Technical change to Push Buttons

Weidmüller Interface GmbH & Co. KG
Klingenbergstraße 16, 32758 Detmold, Germany

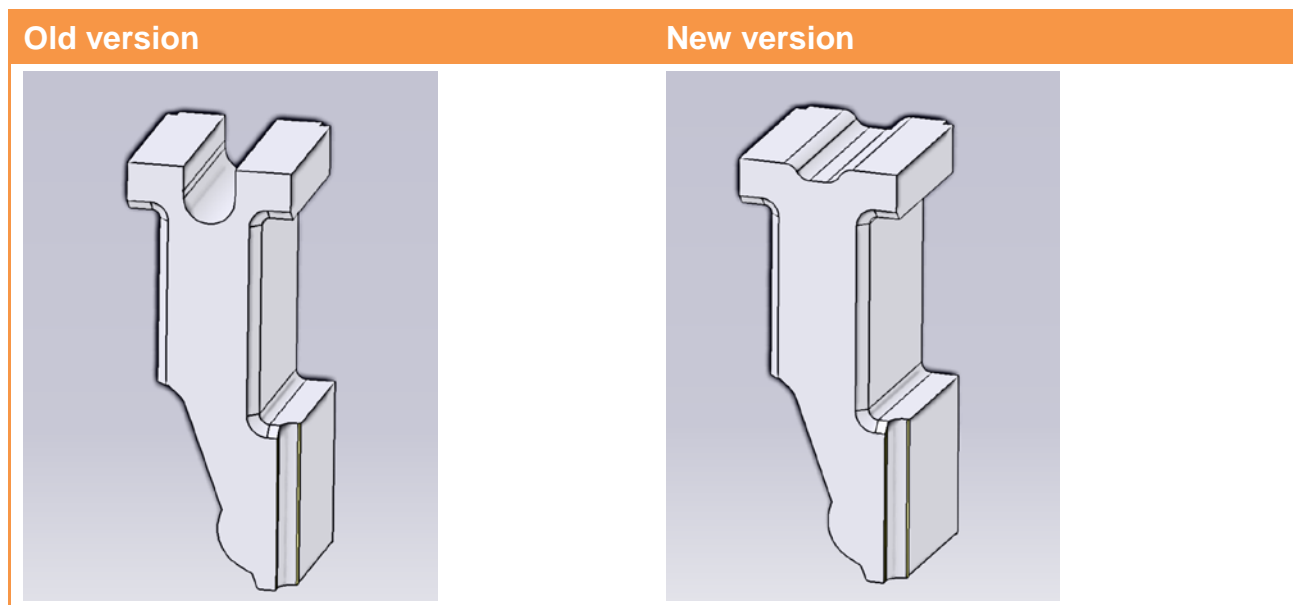
The new push buttons become much flatter, which prevents jamming of the screwdriver.
